Date: August 15, 2018
To: Cumberland Planning Board
From: Carla Nixon, Town Planner
Subject: OceanView at Cumberland Major Subdivision Final Review

Date August 15, 2018
To Town of Cumberland Planning Board
From Carla Nixon, Town Planner
Subject **Major 52 Unit Major Subdivision, Final Review: OceanView at Cumberland – 277 Tuttle Road**

Subject: Planner's Comments for Ocean View

FIELD WK:	SCALE: 1"=40'	SHEET:
DRN BY:	JOB #: 109	C9
CH'D BY:	SS:	
DATE: 7-31-2018	FILE:

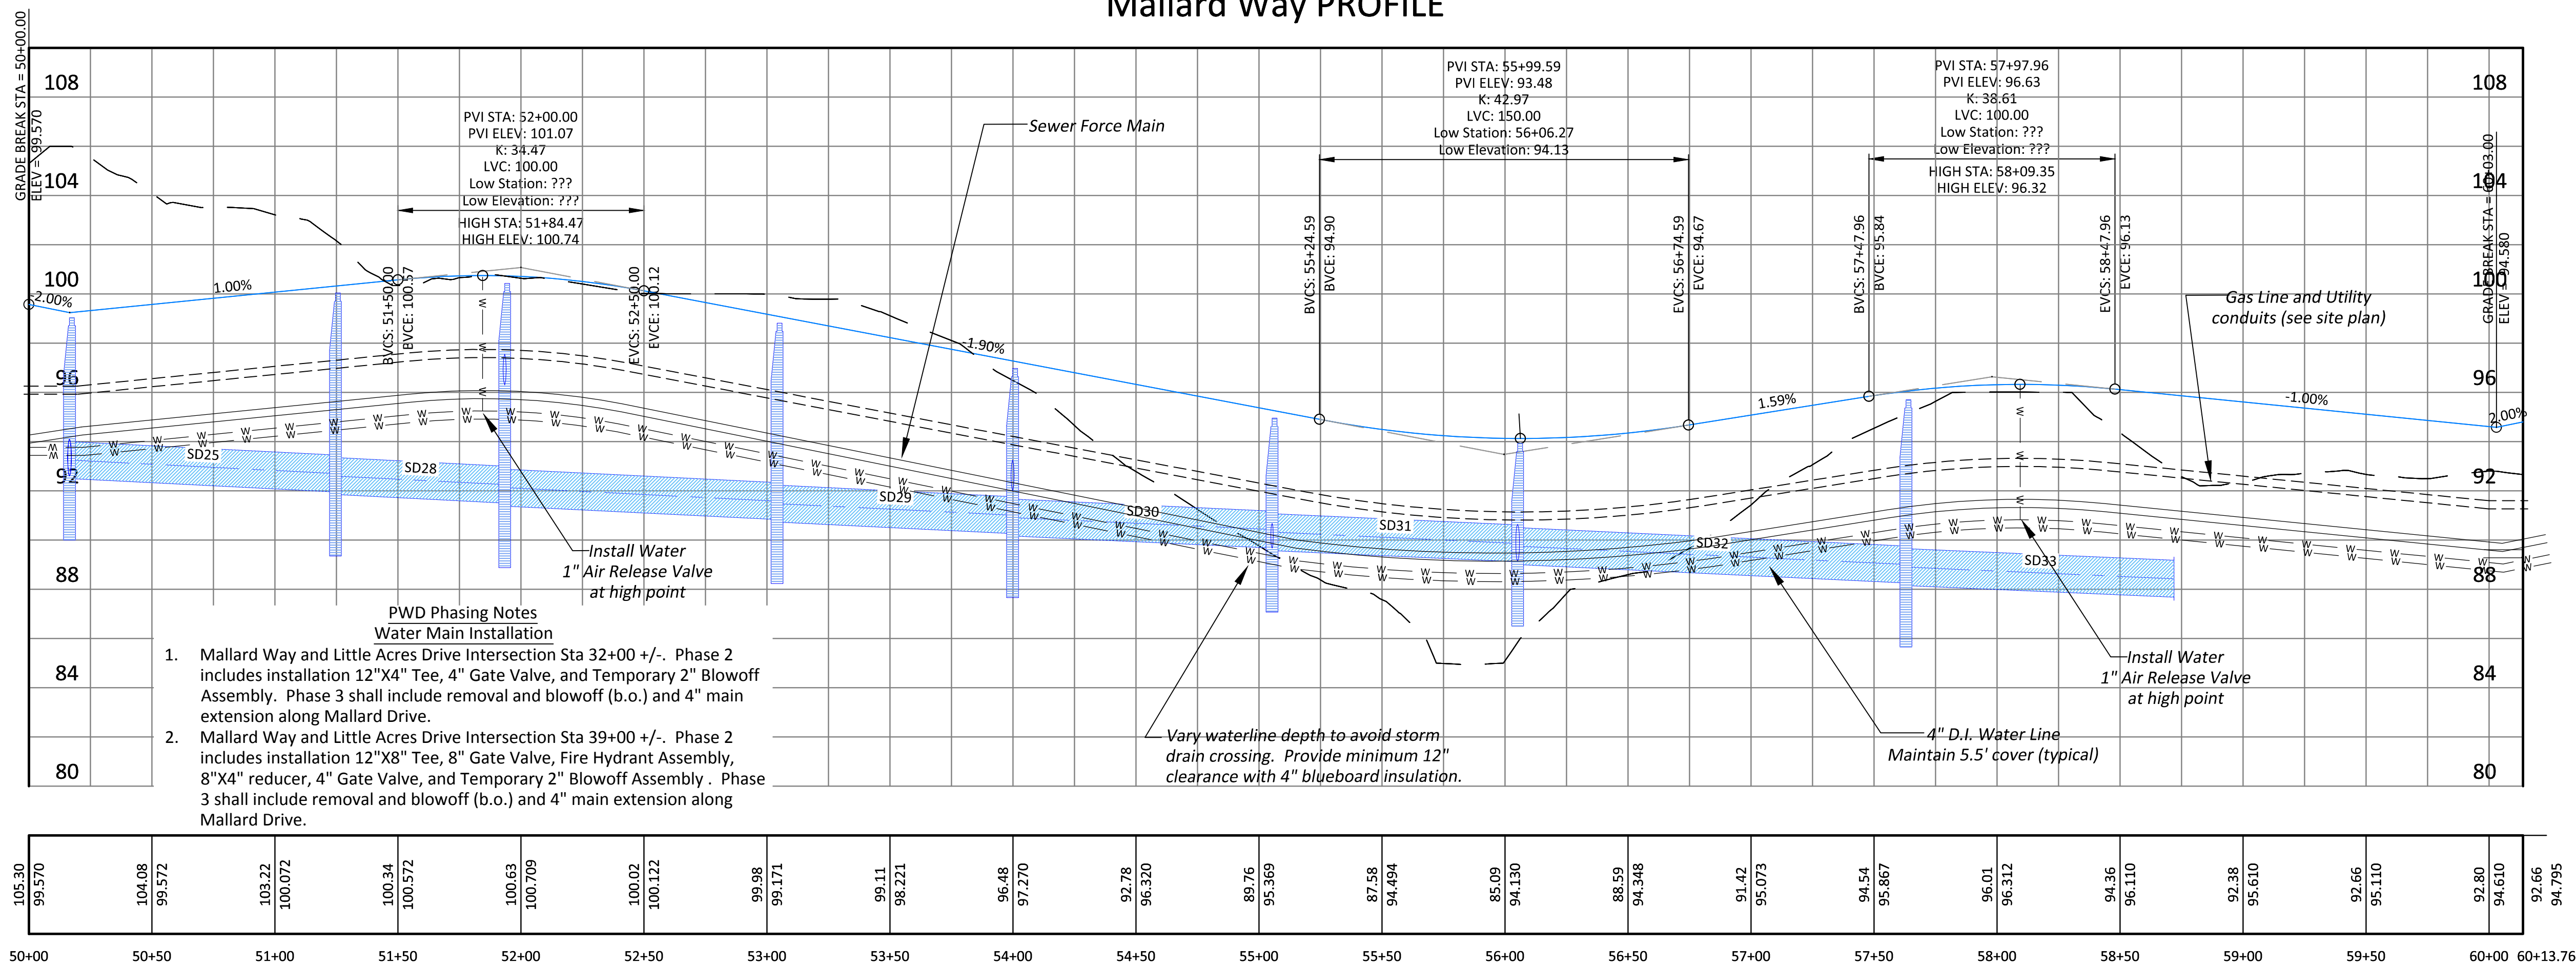
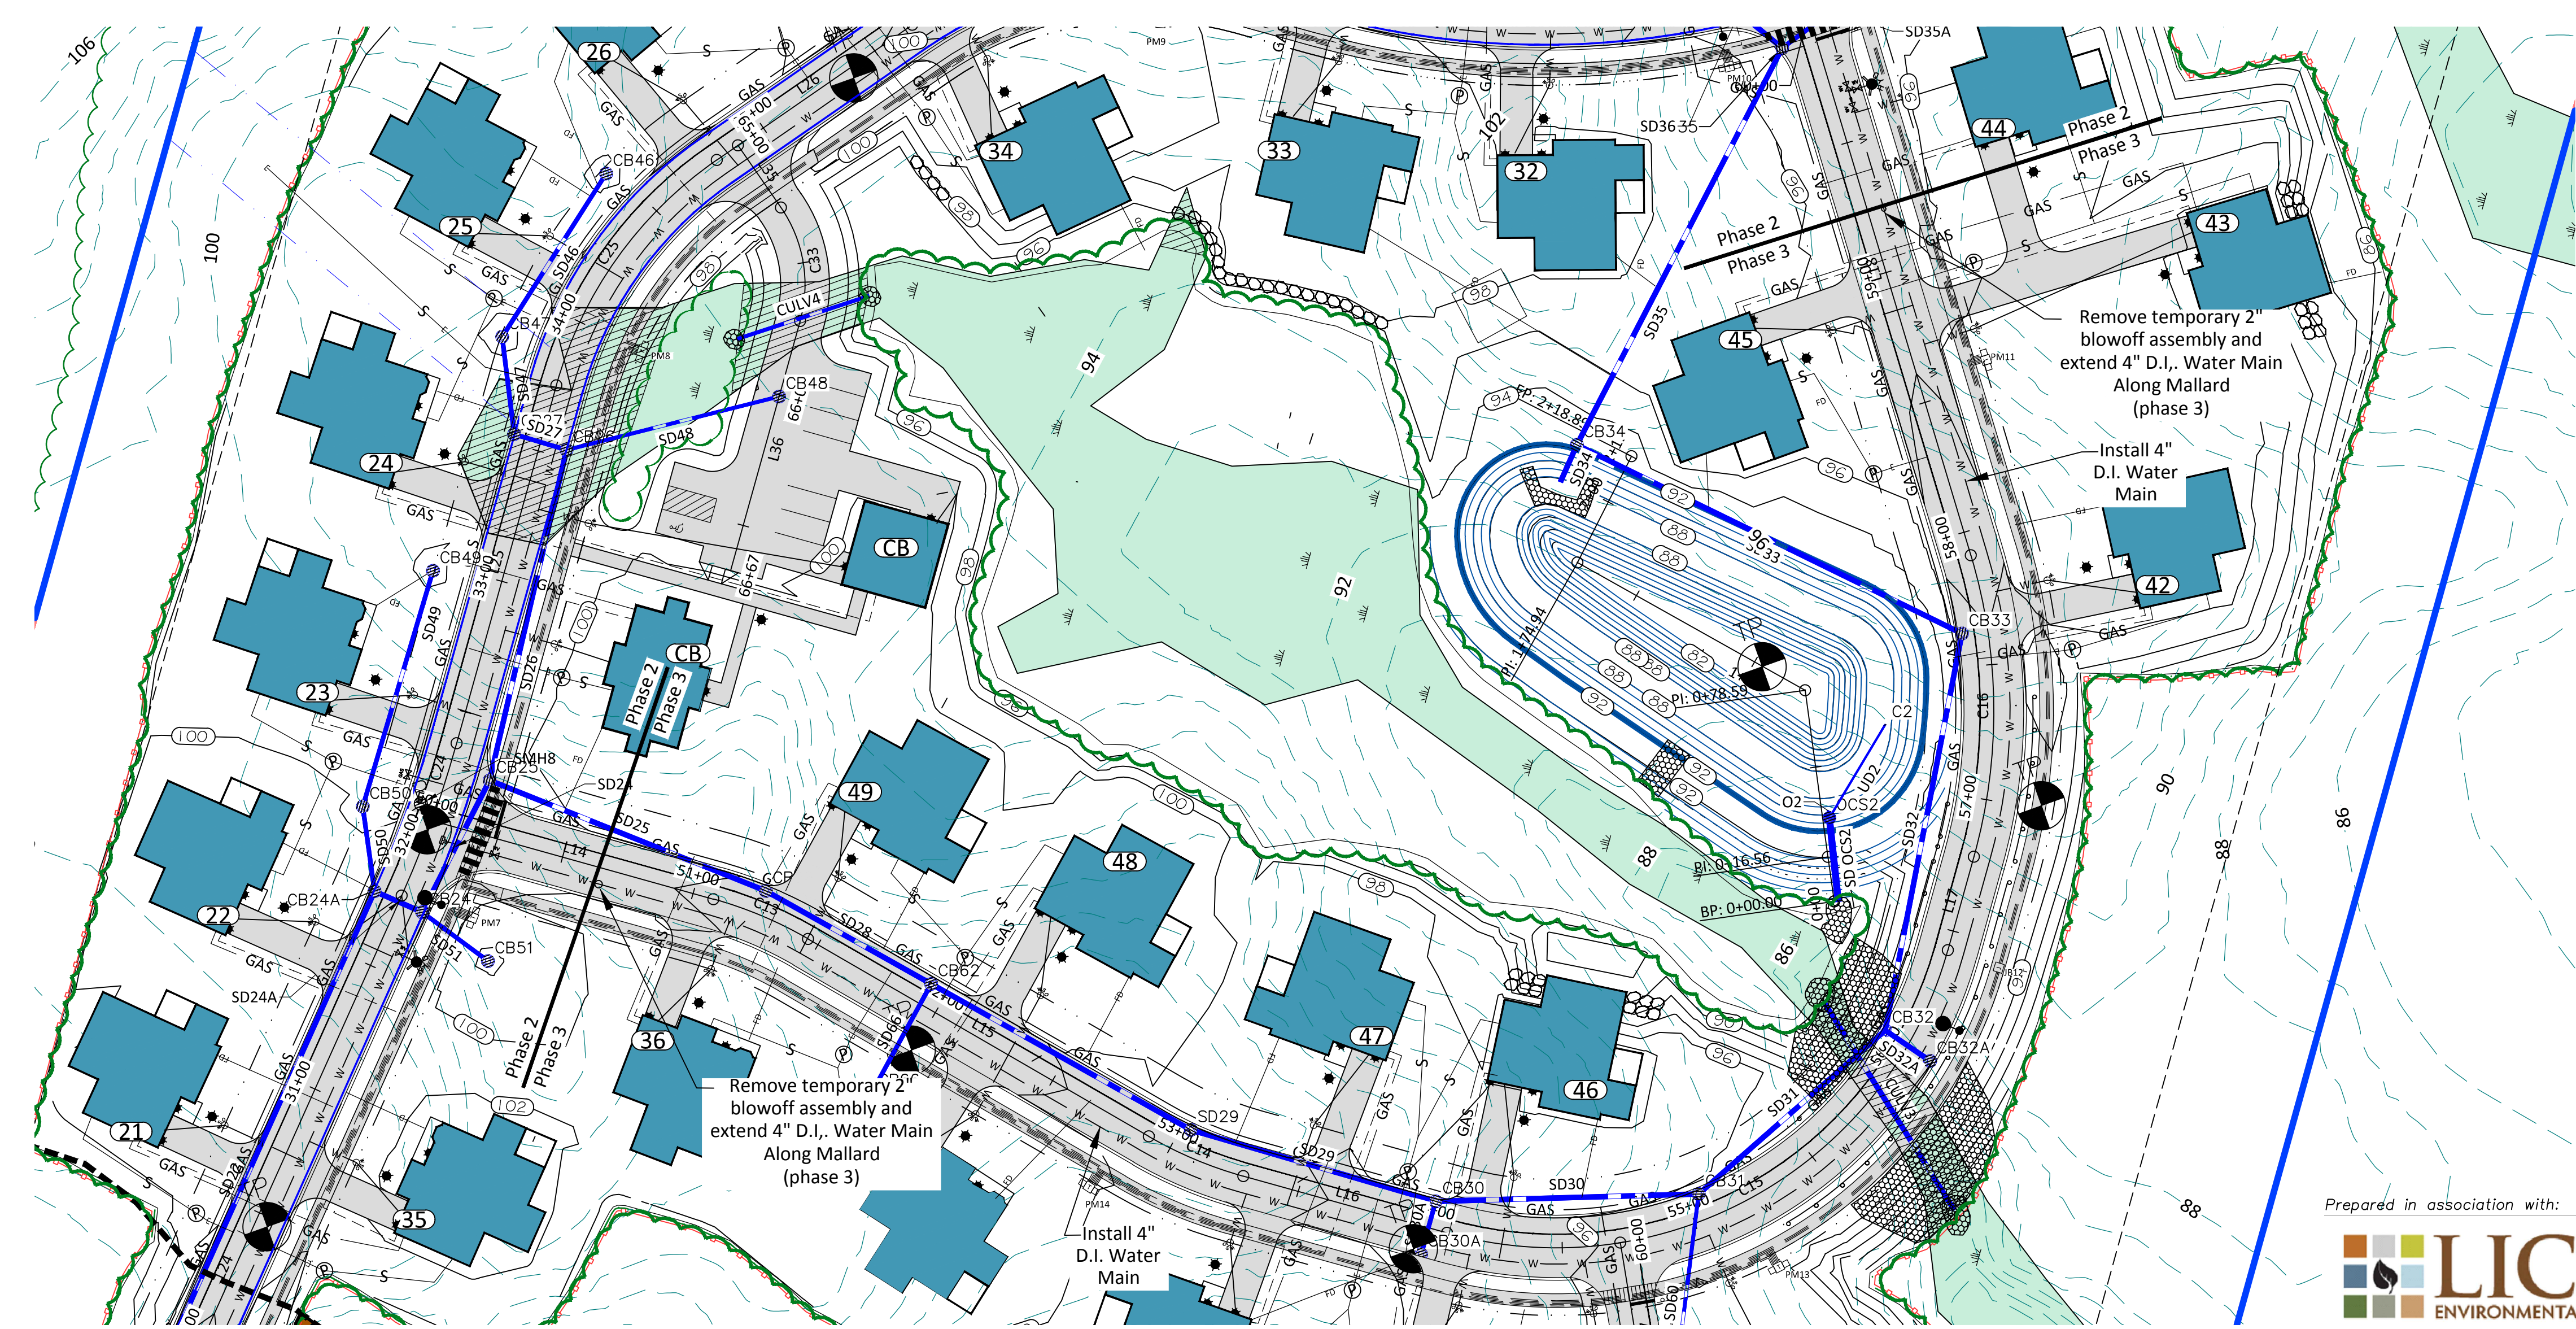
30. On sheet C-9, Low Station and Low Elevation information are missing at STA 51+84.47 and STA 58+09.32.

32. Sheet C-9 does not include a plan view for Azalea Lane.

SHEET: C12

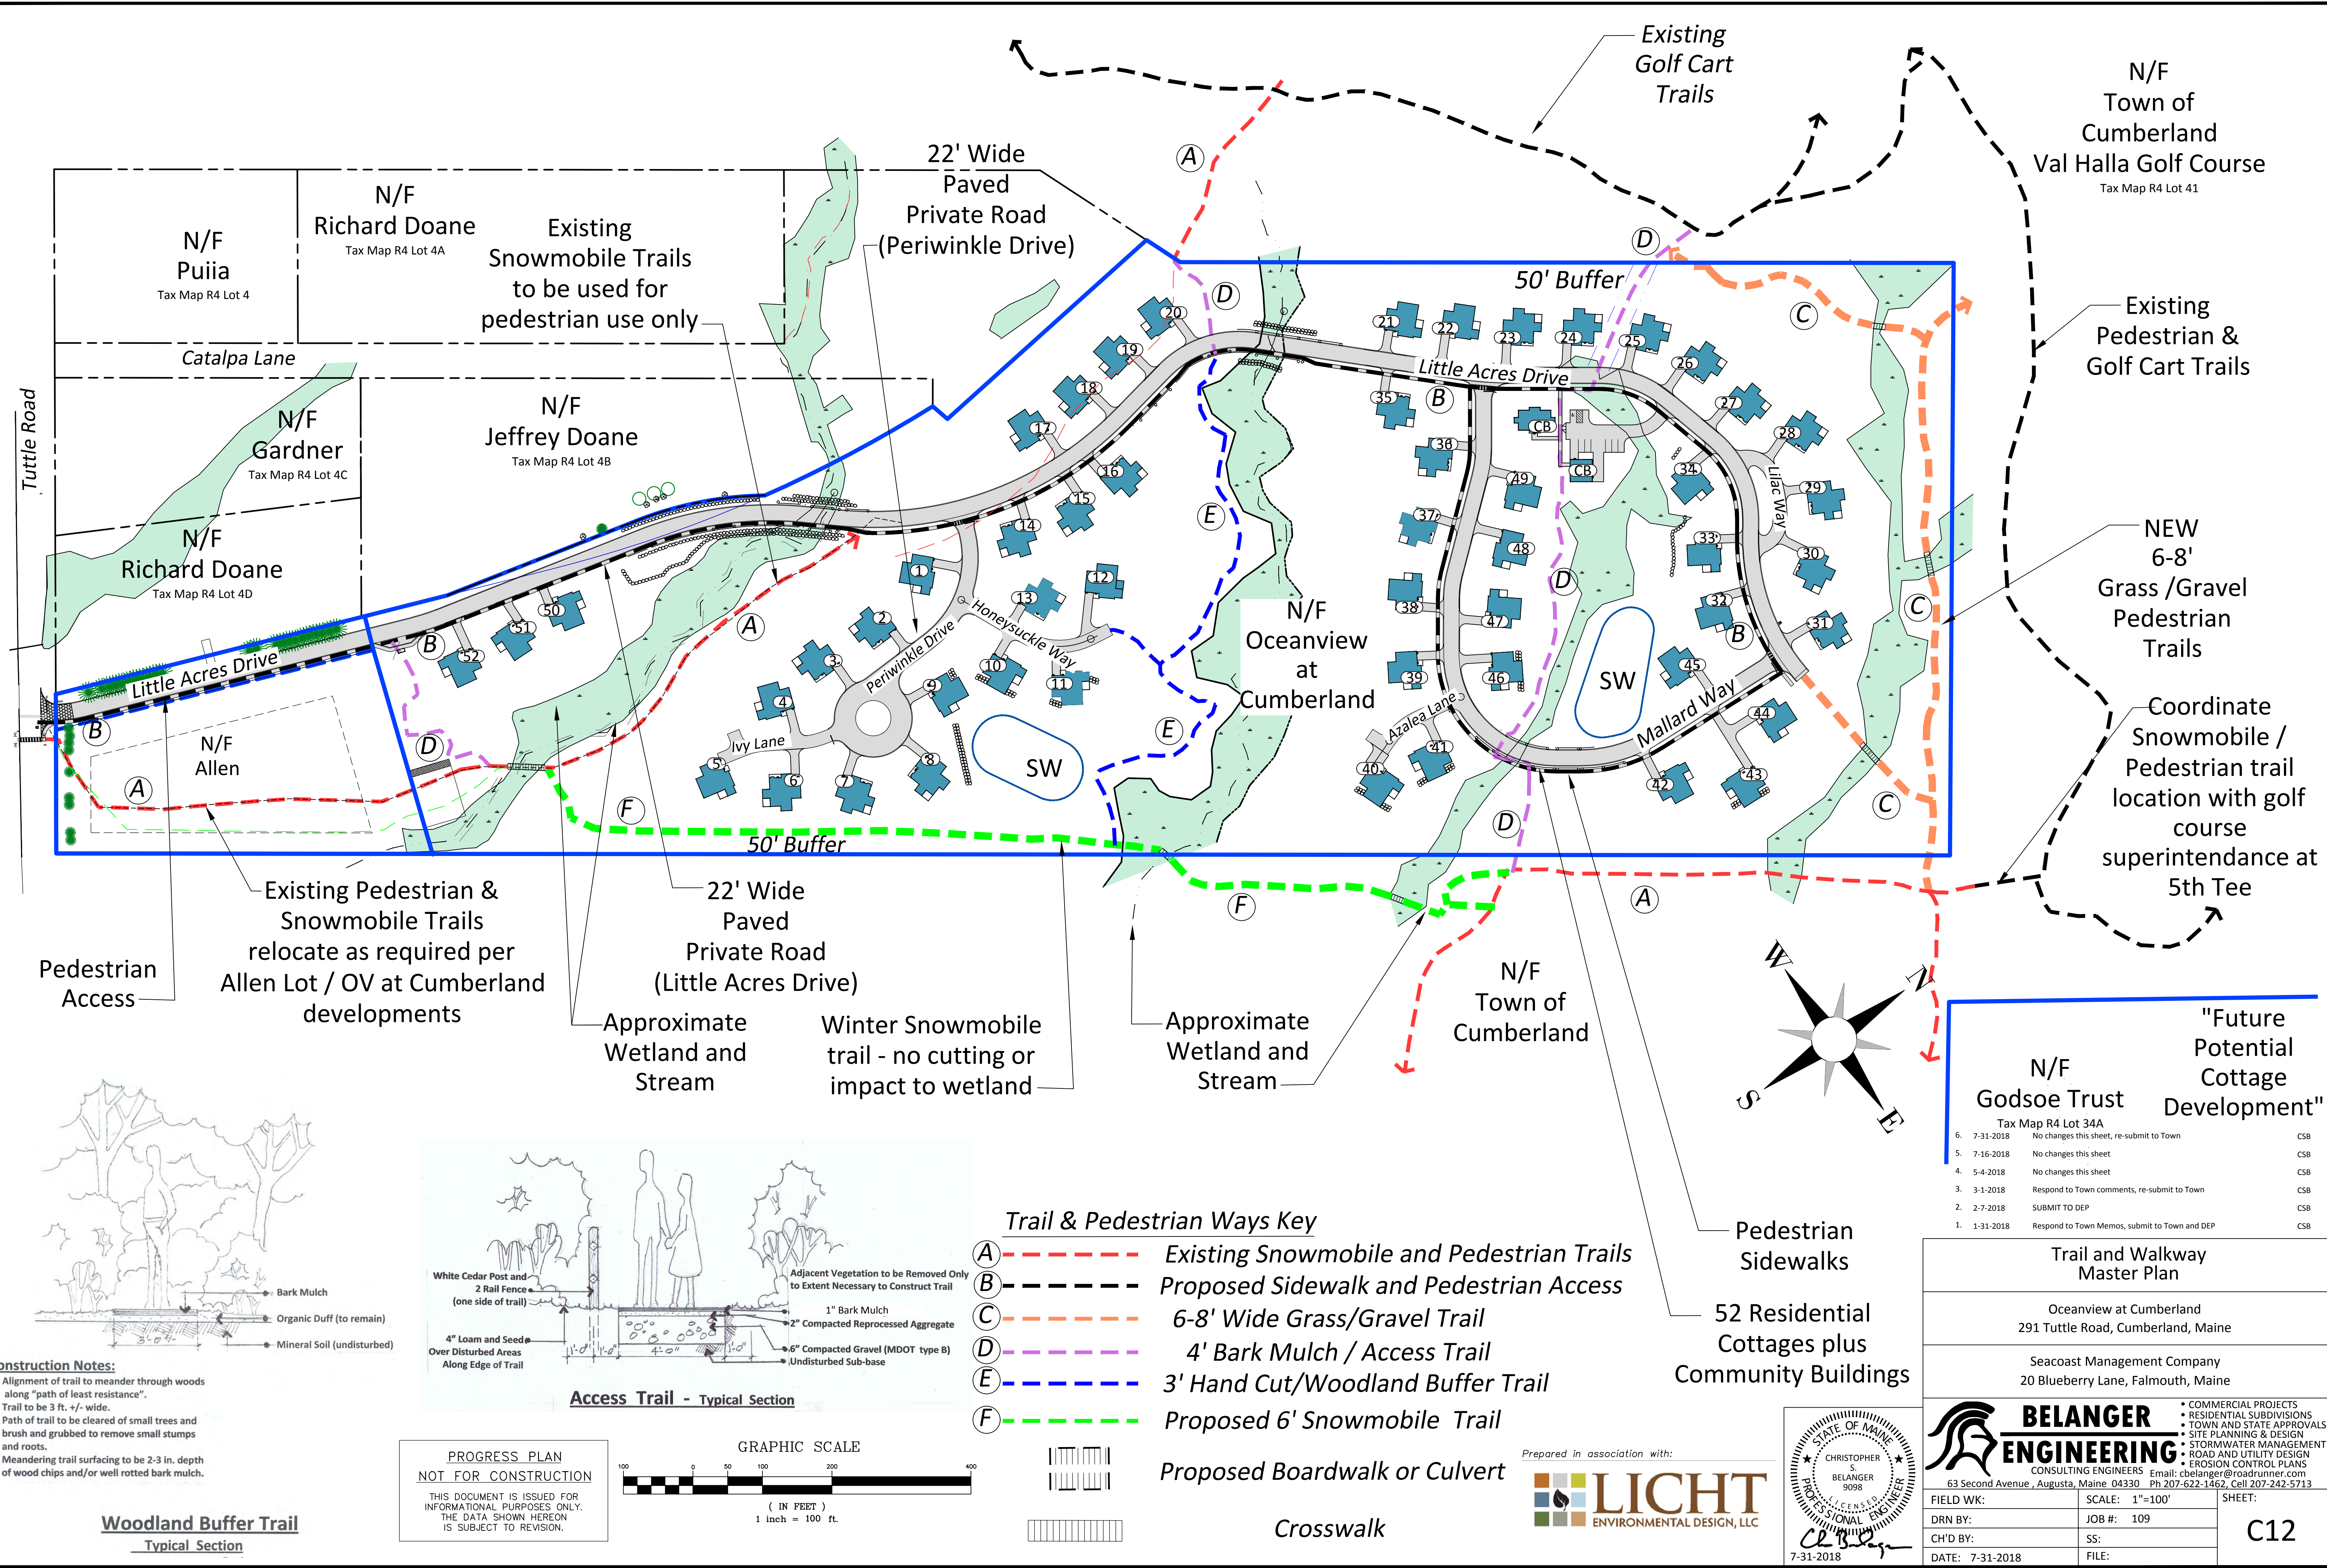
5. On Sheet C 2, what do orange dashes depict? The orange dashes are the 6-8 foot Trail Type C shown on the Trail and Walk Masterplan C-12. Also the Green Dash refers graphically to the Snowmobile/multi use trail type F on the Trails plan C-12.
